Attachment 5  
to U-602512

50.59 Thermo-Lag  
Safety Evaluations

1.4 Title: EVALUATION OF THERMO-LAG IN FIRE ZONE A-1a

USAR Appendix E and F Revision

**FIGURE 4.2.4.5-2**  
**FIRE PROTECTION DEVIATION**  
**CONTROL & DIESEL GENERATOR BLDG.**  
**GRADE FLOOR PLAN EL. 737'-0"**  
**FIRE AREA CB-1**

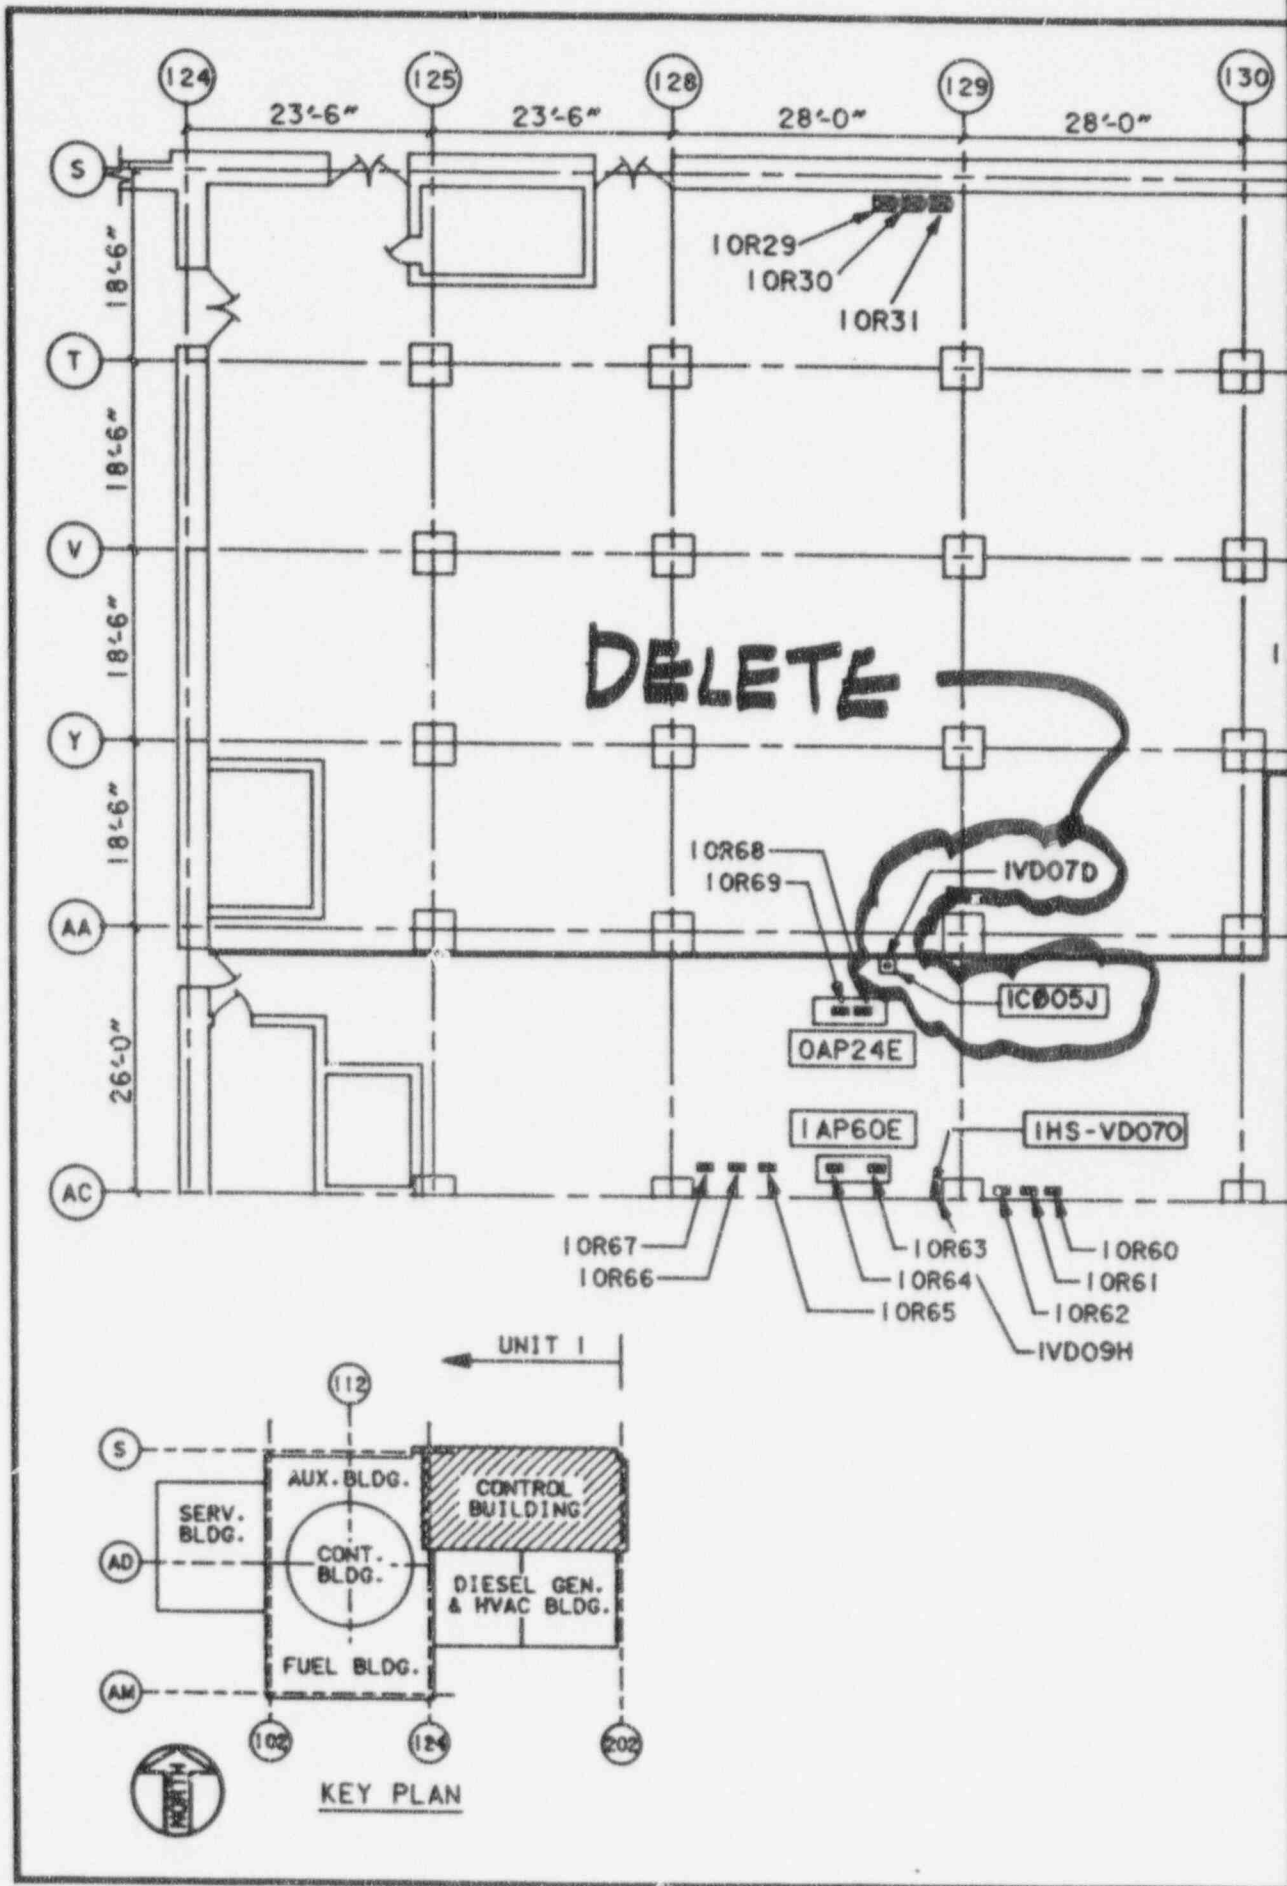
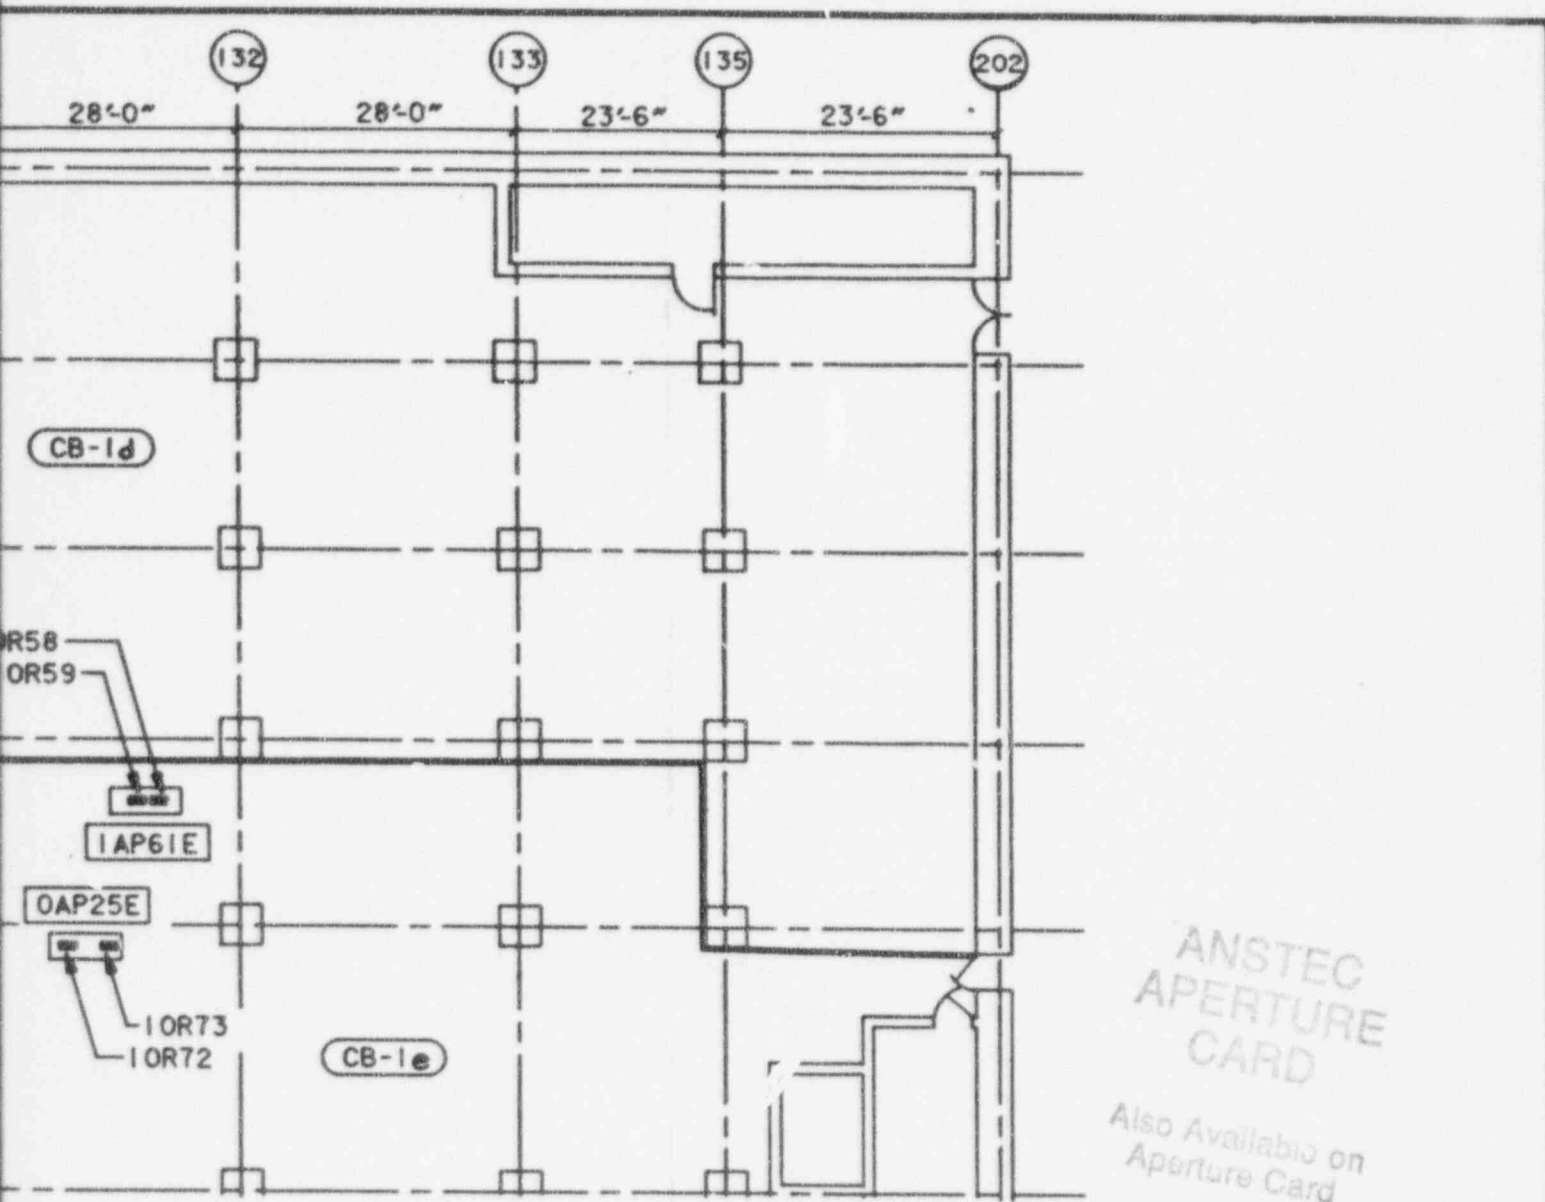
In Fire Zone CB-1e, elevation 737 feet 0 inch (see Figure FP-10a) and above the intermediate roof at elevation 751 feet 0 inch (see Figure FP-11a), Division 1 and 2 electrical cables that belong to the diesel generator, diesel generator HVAC, auxiliary power, shutdown service water, control room HVAC, and the diesel generator fuel oil systems are routed in cable trays within a distance of less than 20 feet (see Cable Tray Figure 9). Also, located in this fire zone are diesel generator building MCCs 1A and 1B. In order to ensure that one shutdown method will be available, the Division 1 and 2 cable trays will be protected as described in Subsection 3.3.1.3.2.

FIGURE 4.2.4.5-4

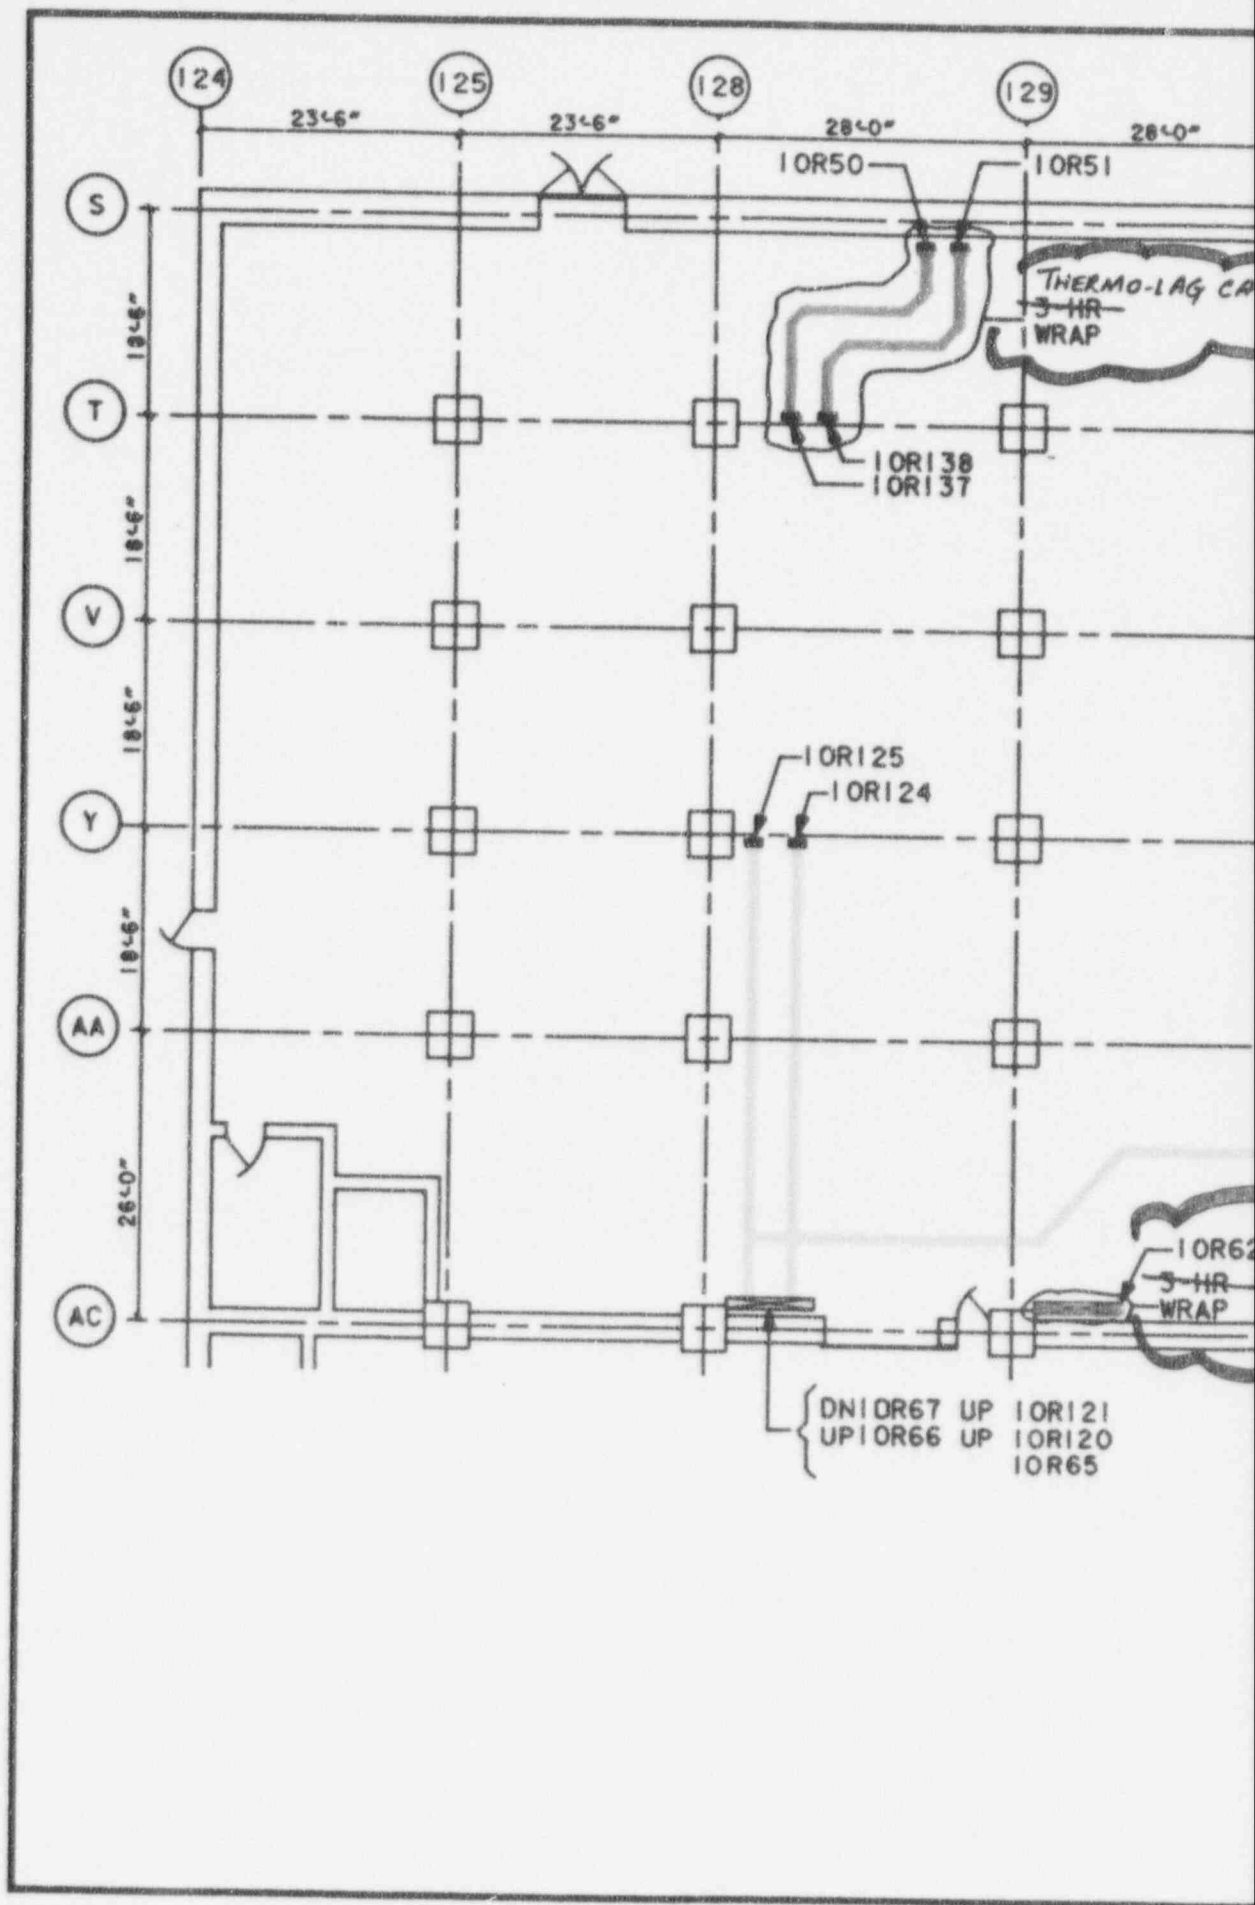
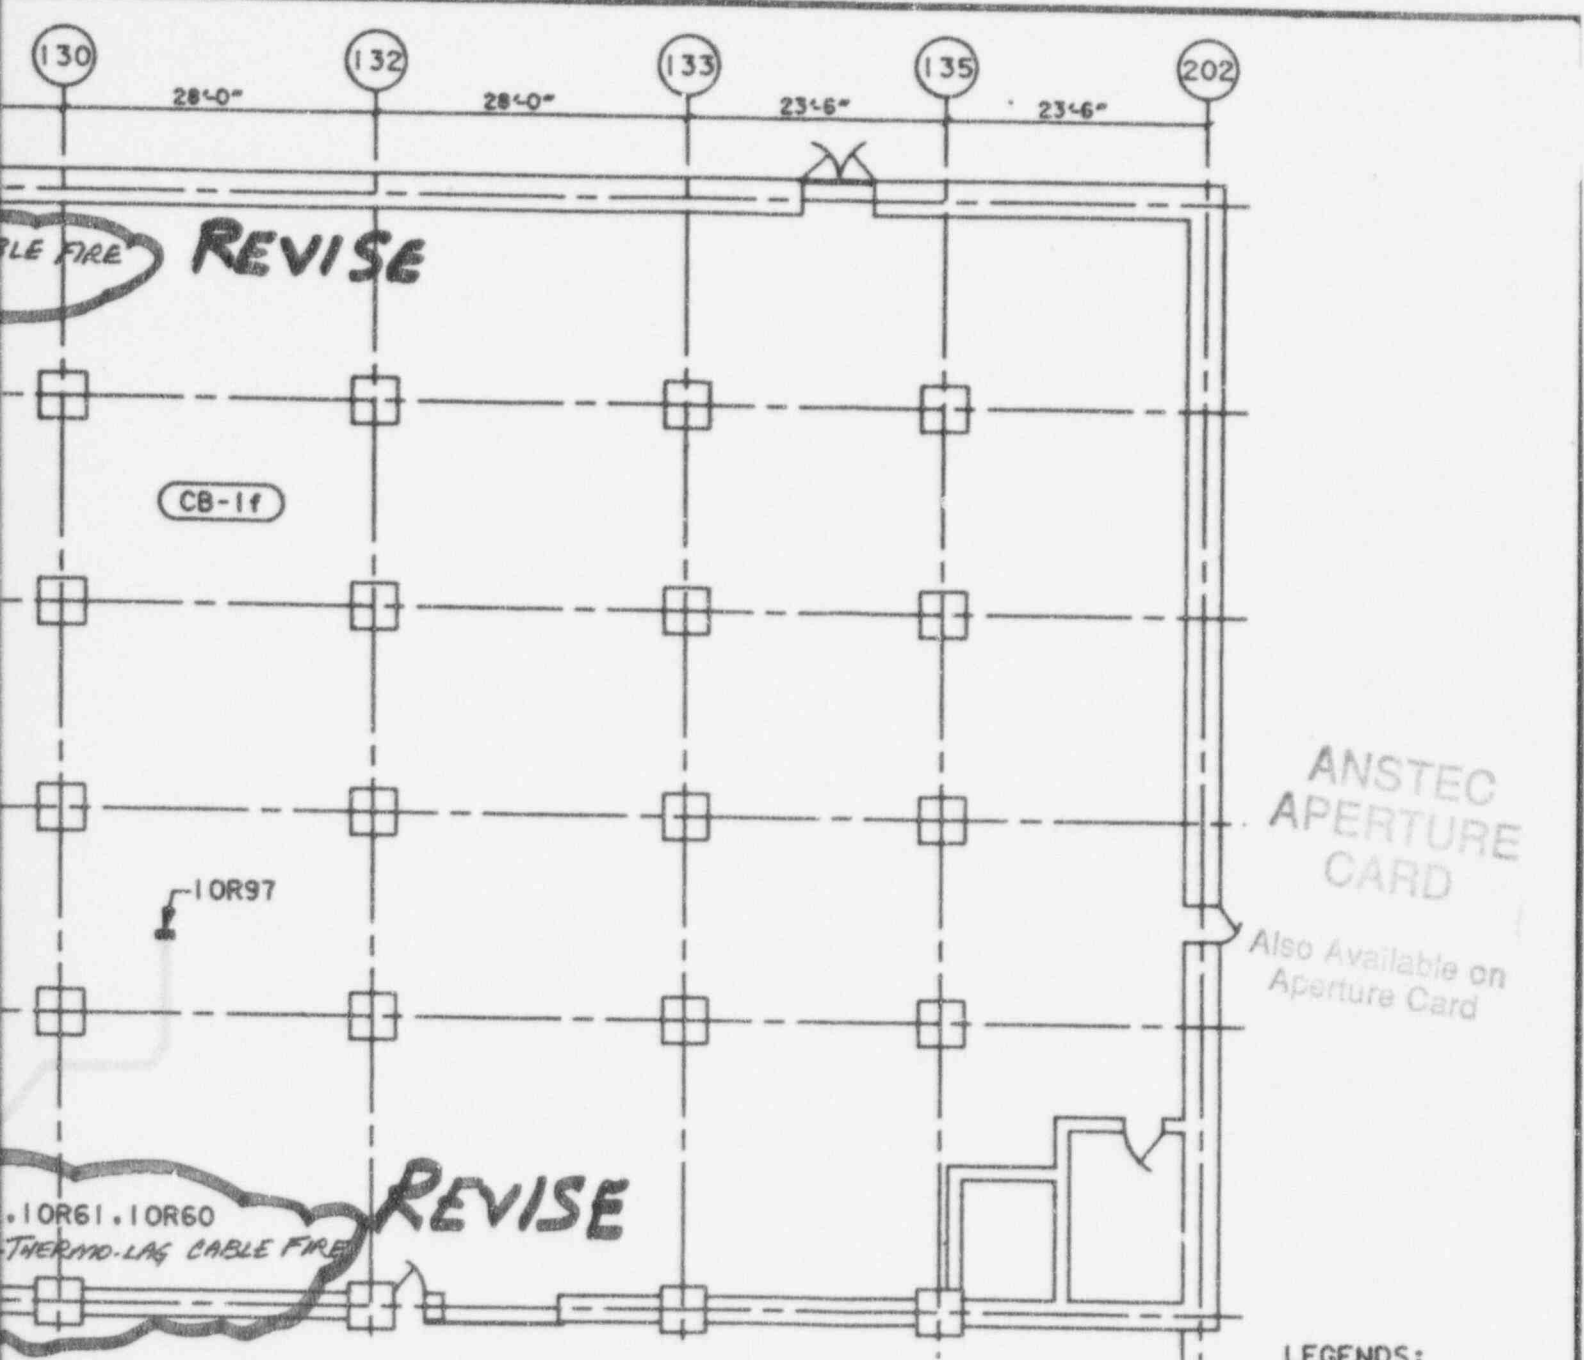
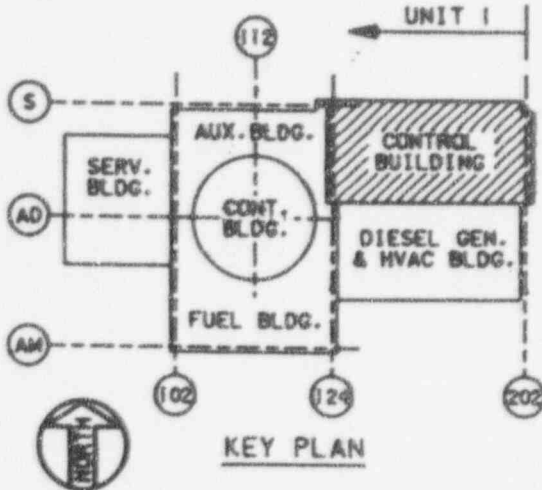
If a fire were to start in Fire Zone CB-1f at elevation 762 feet 0 inch, only Division 1 safe shutdown systems could be affected; all Division 2 safe shutdown systems are protected by a ~~2-hour~~ fire rated material (see Figure 4.2.4.5-4). A safe shutdown would be achieved by Method 2 safe shutdown systems. The possibility of upward fire propagation from Fire Zone CB-1f is limited by the automatic sprinkler system that is provided at the ceiling of elevation 762 feet 0 inch around the HVAC shaft at column row 125/AC, the 3-hour fire rated ceiling between column rows 124-130 and column line SAC, and the sealing or cable risers penetrating the ceiling protect one safe shutdown division. Upward fire propagation can occur through the open hatch at column row 135/AC, which communicates with elevation 825 feet 0 inch (Fire Zone CB-1i). The concern is discussed later.

The original design in fire zone CB-1f utilized the option of 3-hour fire barrier (III.G.2.a) using Thermo-Lag to enclose the trays of Division 2 safe shutdown power, instrumentation and control cables. Figure 4.2.4.5-4 shows the locations of Thermo-Lag in fire zone CB-1f. In addition, as shown on Figure FP-12b, an ionization fire detection system is provided for the entire fire zone.

CPS-USAR  
 TABLE 4.2.4.3-1

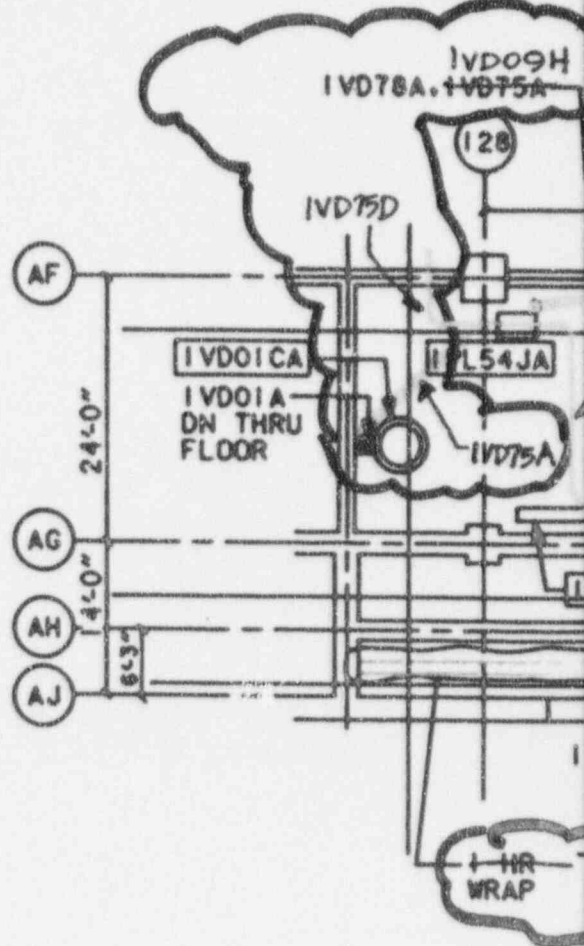
<del>1DG75C</del>	<del>19108C</del>	<del>D-8</del>	<del>K1E</del>	<del>1DG01KA</del>	<b>DELETE</b>
<del>1DG75D</del>	<del>19108C</del>	<del>D-8</del>	<del>K1E</del>	<del>1DG01KA</del>

1VD09H	<del>19108C</del>	D-8	K1E	1HS-VD070*	<b>REVISE</b>
1VD78A	<del>19108C</del>	D-8	K1E	1TE-VD007	
<del>1VD78A</del>	<del>C92125</del>	<del>D-8</del>	<del>K1E</del>	<del>1TE-VD007</del>	<b>DELETE</b>
1VD01A	C92109	D-8	P1E	1VD01CA	
1DG31A	C92118	D-8	P2E	1DG01KB	
1DG31B	C92120	D-8	P2E	1DG01KB	
1VD01E	C92124	D-8	C1E	1KY-VD080*	
1VD04E	C92124	D-8	C1E	1PDS-VD030	
1VD18B	C92124	D-8	C1E	1TIT-VD007*	
1VD75A	C92137	D-8	K1E	1TE-VD001, 1TIC-VD001	
1VD75C	C92144	D-8	K1E	1TIC-VD001*

**FIGURE 4.2.3.3-1**  
**FIRE PROTECTION DEVIATION**  
**DIESEL GENERATOR BLDG.**  
**MEZZANINE FLOOR PLAN EL. 762'-0"**  
**FIRE AREA D-8**

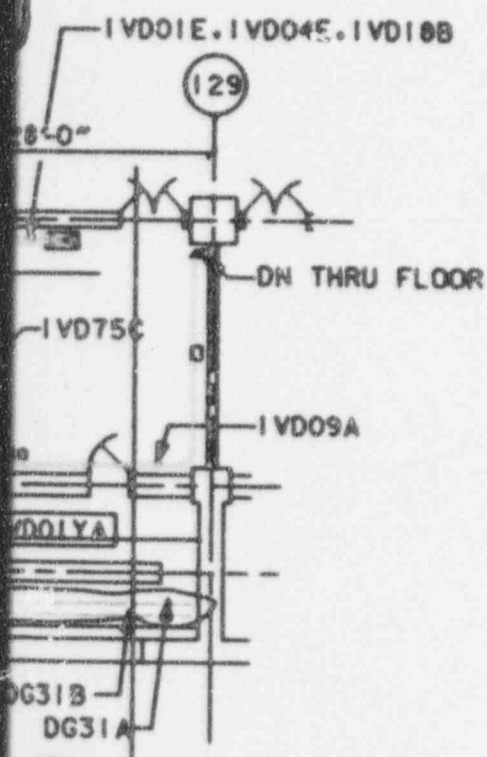
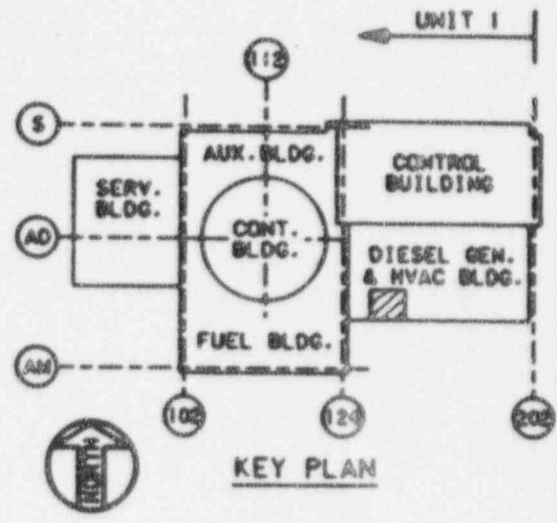
This cable is shown in fire area D-8 on Figure 4.2.4.3-1 of USAR Appendix F, but is omitted from fire area D-8 in Figure 4.2.3.3-1 and Tables 4.2.3.3-1 and 4.2.4.3-1 of USAR Appendix F.

Fire Area D-8 does not have a complete fire detection system. The Division 2 diesel-generator cables, 1DG31A and 1DG31B (see Figure 4.2.3.3-1), are in conduit and are protected by ~~fire~~ fire rated material and local thermal fire detection as shown in Figure FP-12b. The fire loading in this fire area is low. The Division 2 cables are separated from the combustibles in the area by a missile wall and a reinforced concrete that has two HVAC ventilation openings. Based on the partial fire detection provided, low combustible fire loading, and separation from combustibles, additional fire detection is not necessary in Fire Area D-8.

**REVISE**
